SUBJECT: FCC Class II Permissive change for FCC ID: **KR5TIS-09DH**

We, **Continental Automotive GmbH**, would like to request a Class II Permissive Change for the FCC ID: **KR5TIS-09DH**. It is to the certified device which was originally granted on 2018/9/13 under FCC ID: **KR5TIS-09DH**

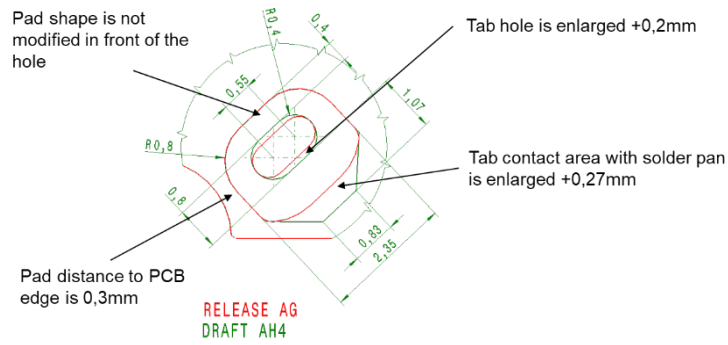
- Foot print update for LF coil – same location (updated dimensions for inner and outer length of the pads)

- Foot print update for battery hole;
